Trinity Wharf Development

.....
Further Information Response

Trinity Wharf, Trinity Street, Wexford

Further Information Response

Figure 1.1 **Annex I Habitat Loss Breakdown**

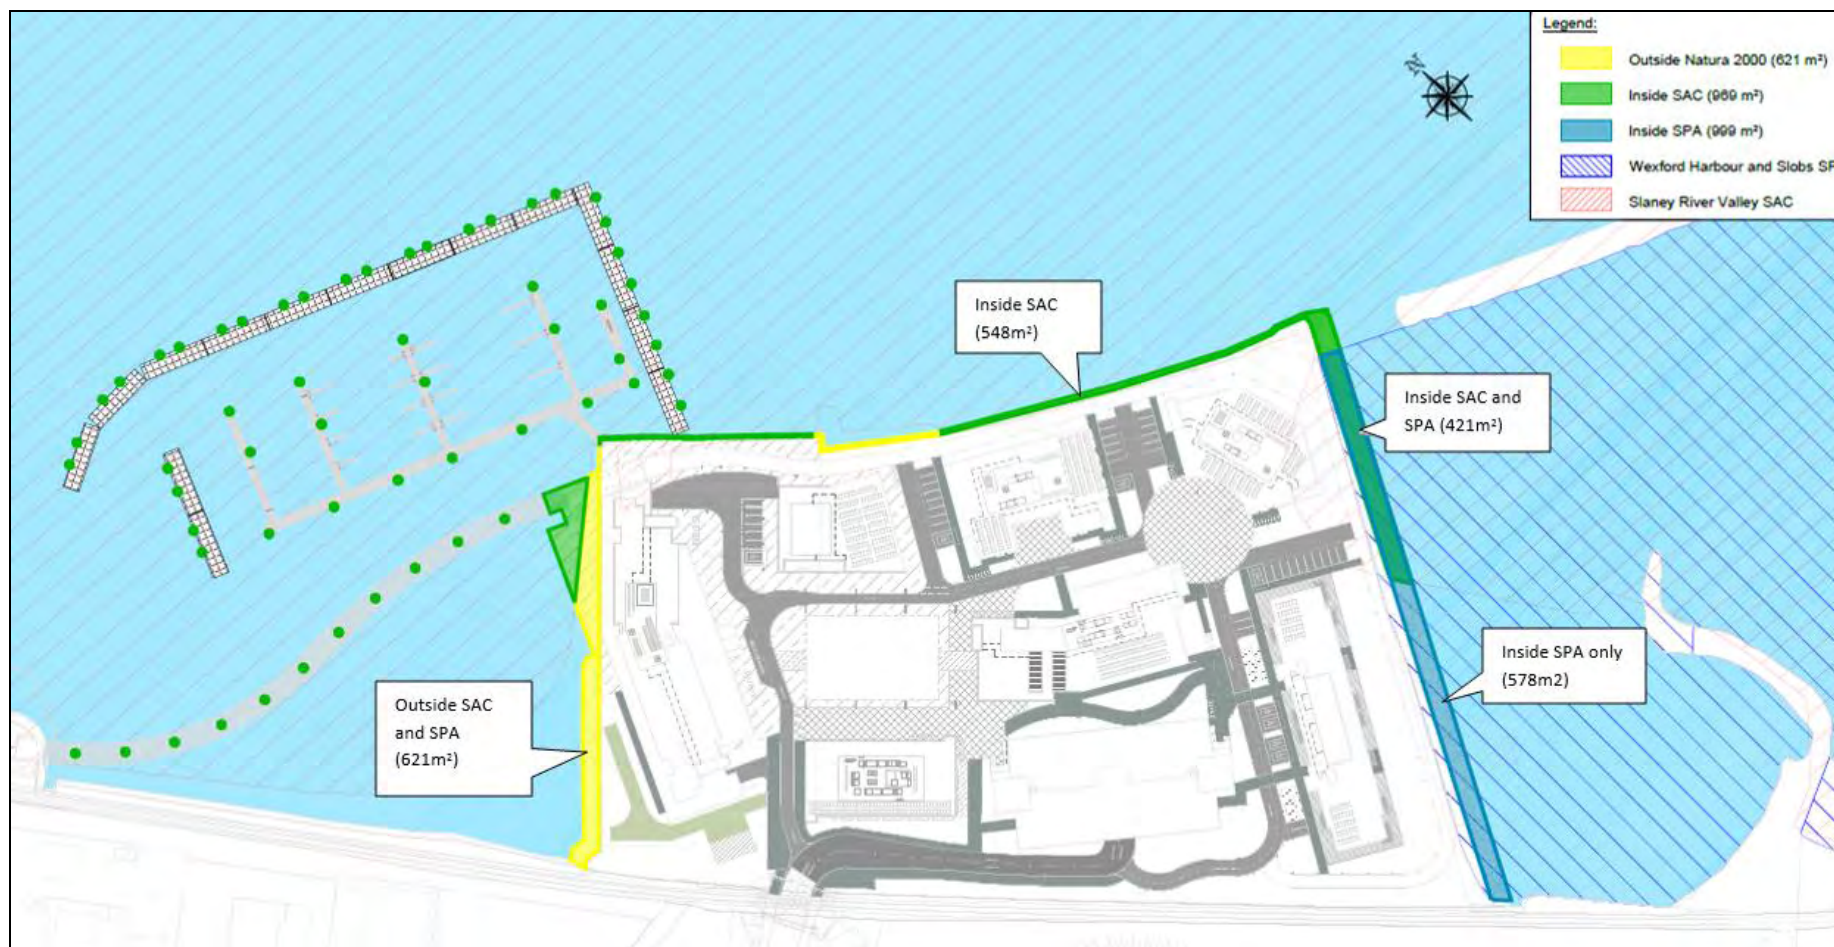
You are requested to provide clarity on the estimated area of permanent habitat loss of subtidal benthos in relation to the targets set as part of the Conservation Objectives for the habitat Type Estuaries [11301] and Mudflats and Sandflats not covered by seawater at low tide [1140] for the Slaney River Valley Special Area of Conservation.

Note 1: the final figure in the Natura Impact Statement is unsubstantiated at 1,547 m² with clearer information presented in the Biodiversity Chapter and in the Benthic study.

Please clarify if this takes account of the overlap between the extent of the Special Area of Conservation and the Special Protection Area as this is not clear in the Natura Impact Statement.

The figure of 1,547m² consists of 969m² within the Slaney River Valley SAC and 999 m² within the Wexford Harbour and Slob SPA, with, a 421m² overlap. The 969m² within the Slaney River Valley SAC is classified as both “Estuaries” and “Mudflats and sandflats not covered by seawater at low tide” and represents c. 0.005% and c. 0.009%, respectively, of the estimated total area of these habitats within the SAC.

A breakdown of the directly impacted Annex I habitats is presented in Figure 1.1 below. The overall area of the marina and boardwalk has not been included as water will be allowed to circulate freely underneath these structures.

ACCESS ROAD SERVICES LAYOUT PLAN

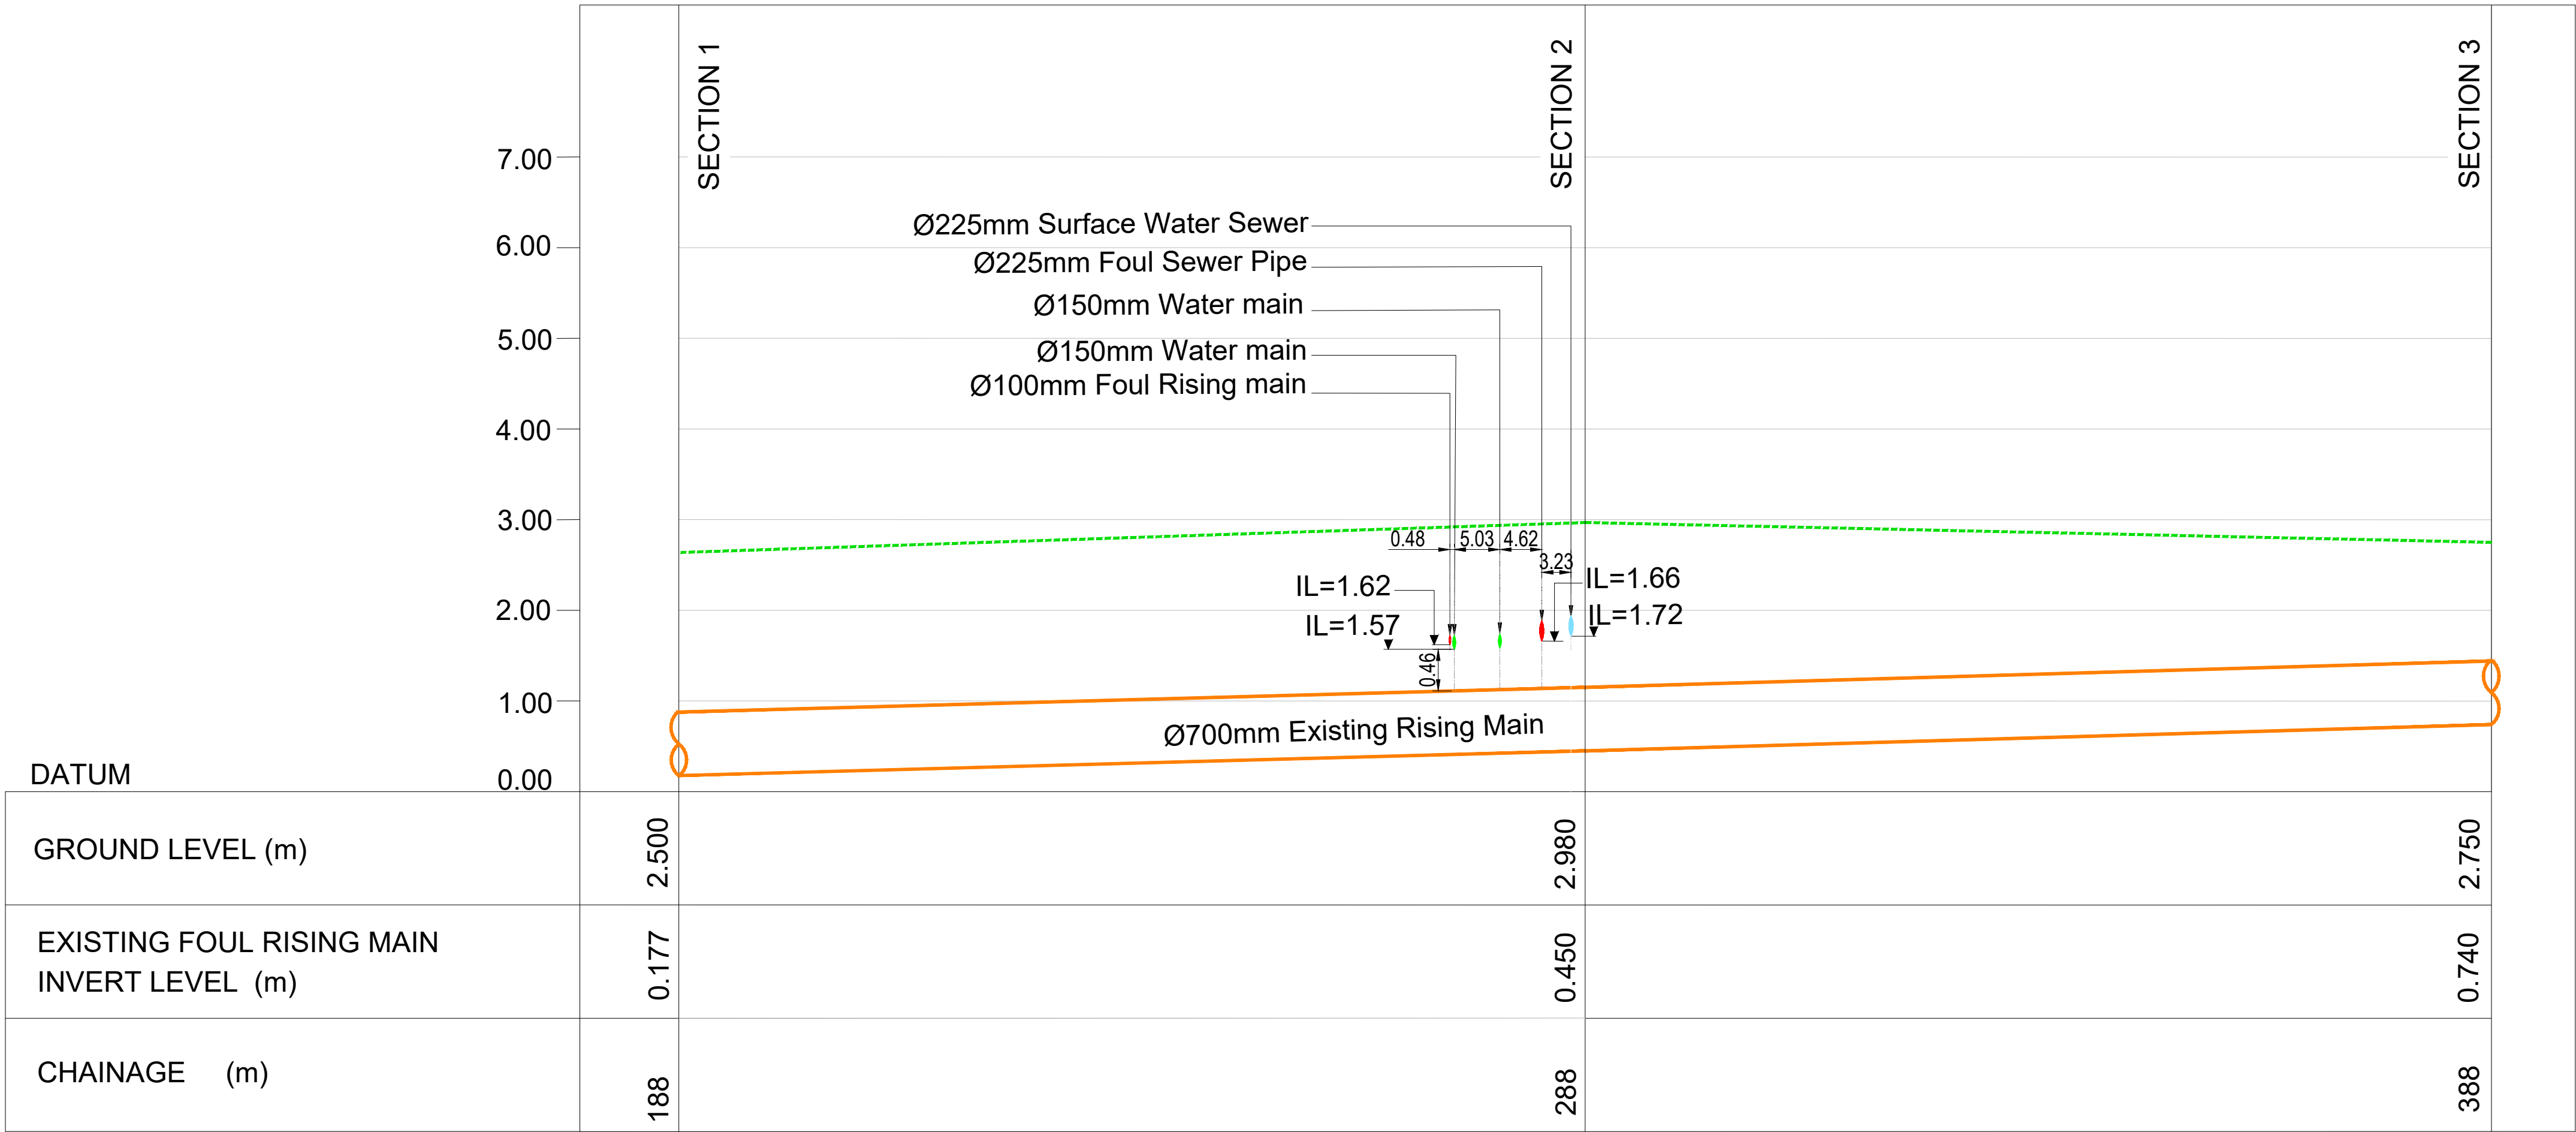
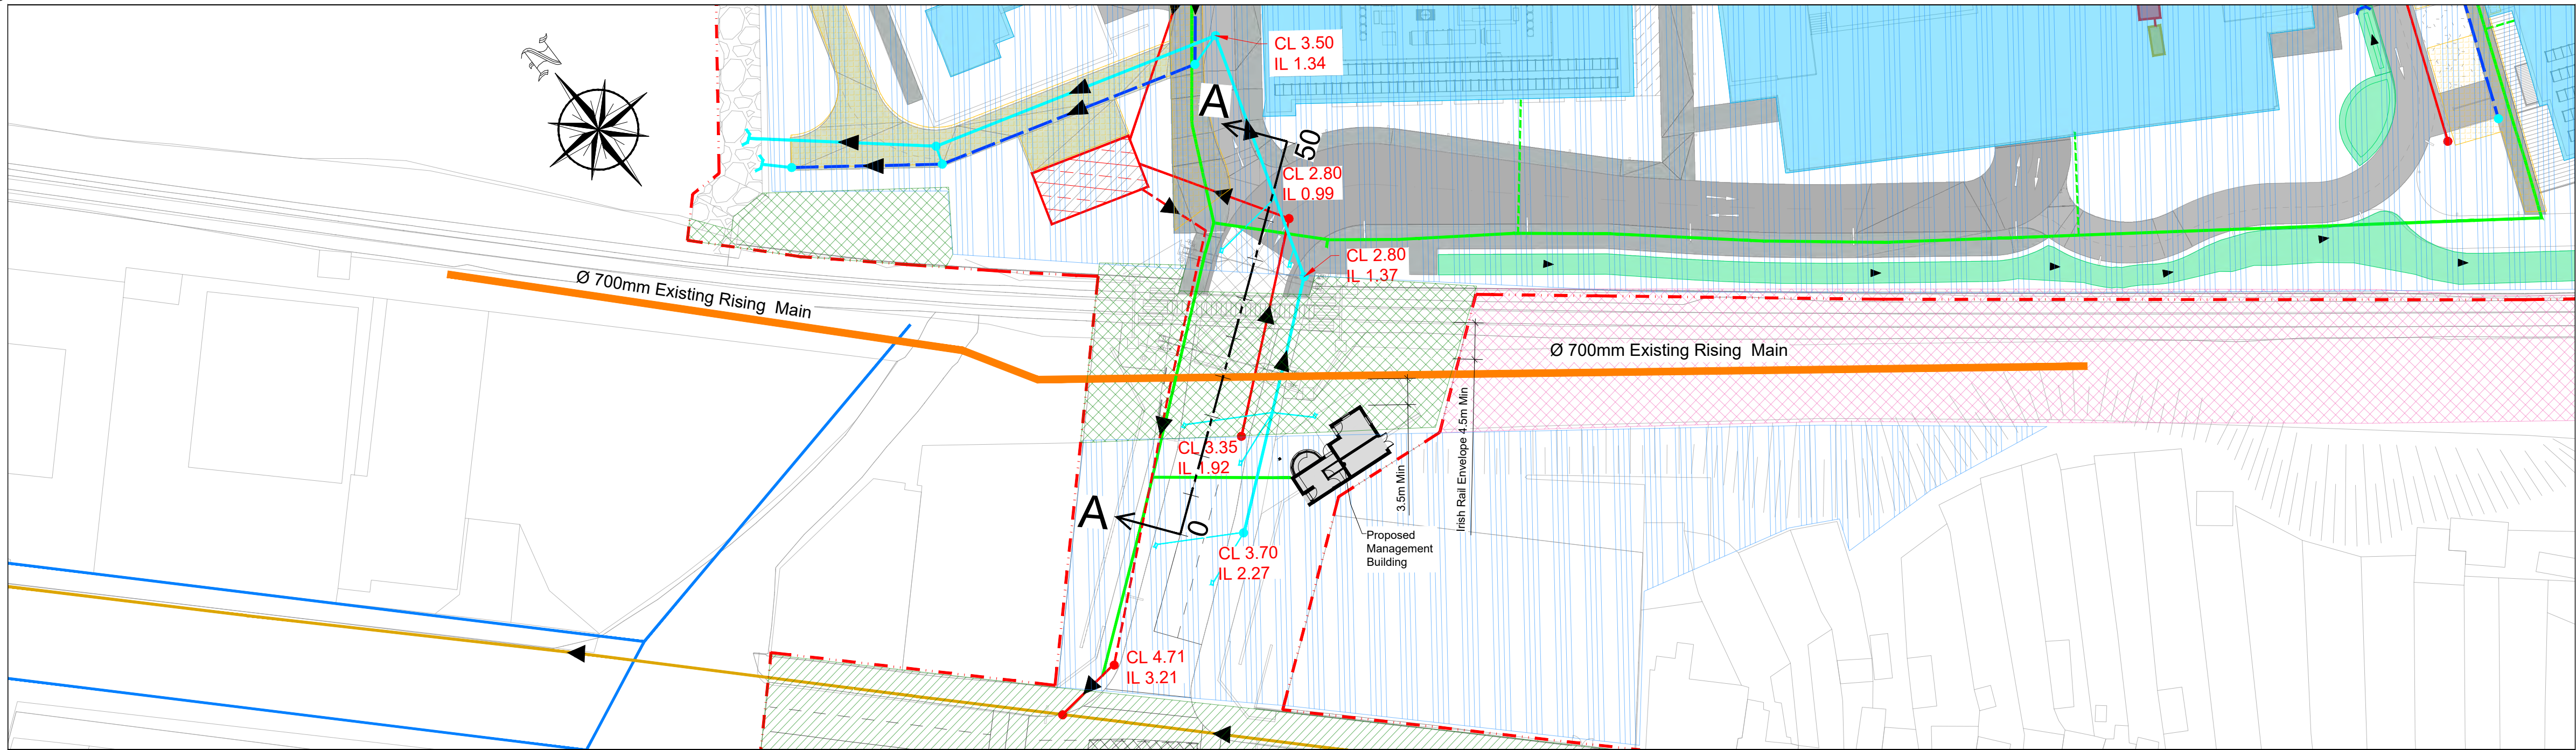
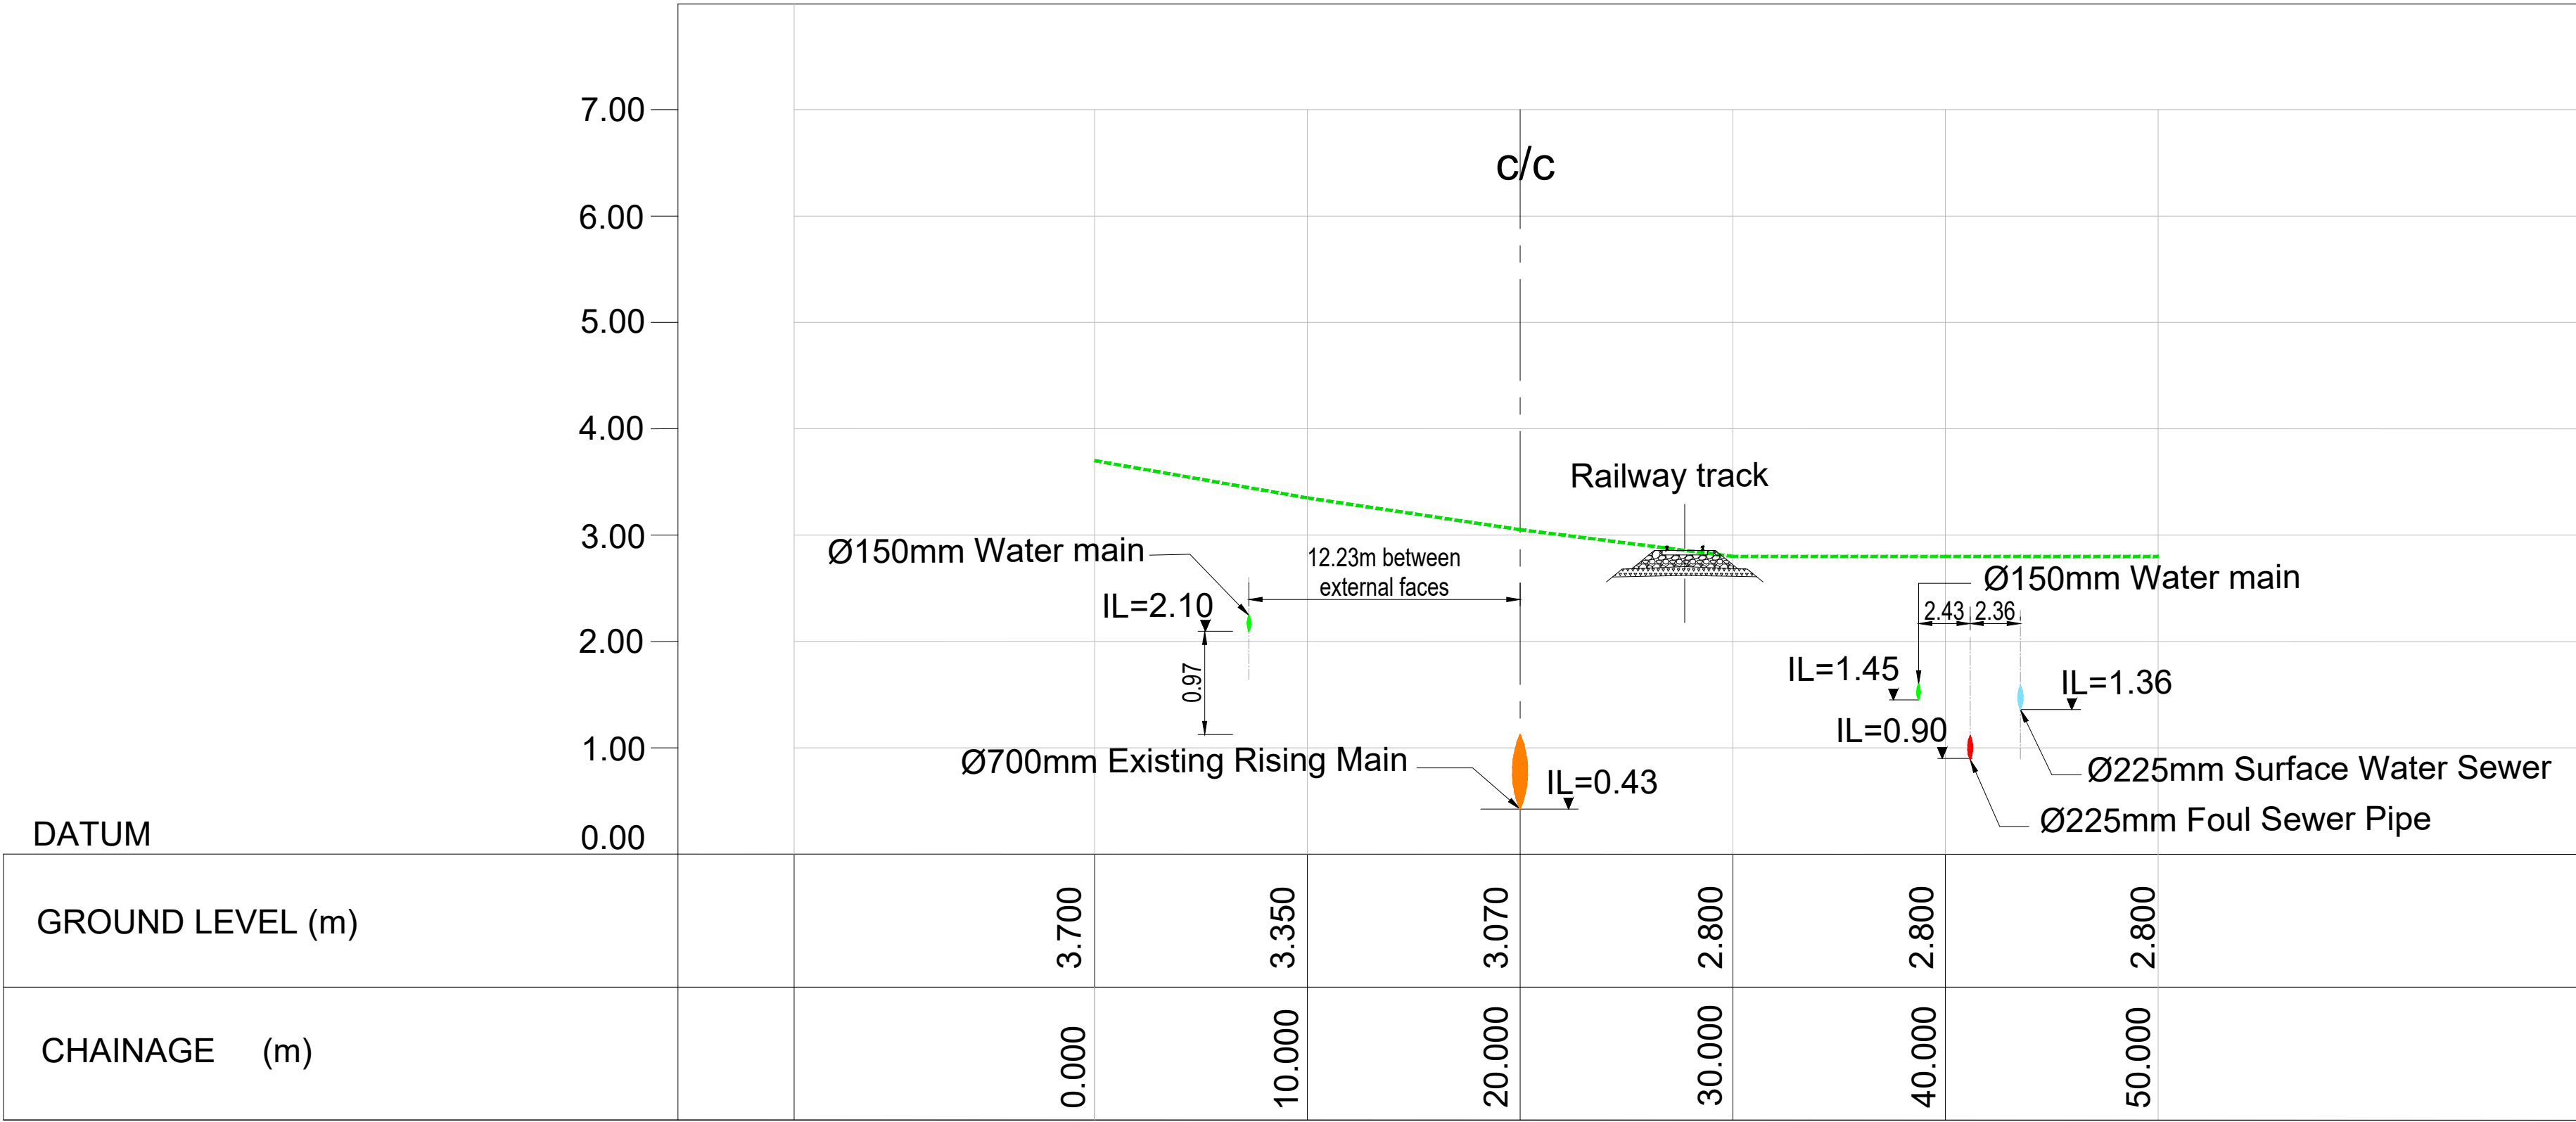
- c. *Please provide a revised long section for the access road which provides information on the location of proposed storm sewers, foul sewers and watermains and how these would interact with the existing railway line and existing rising main.*
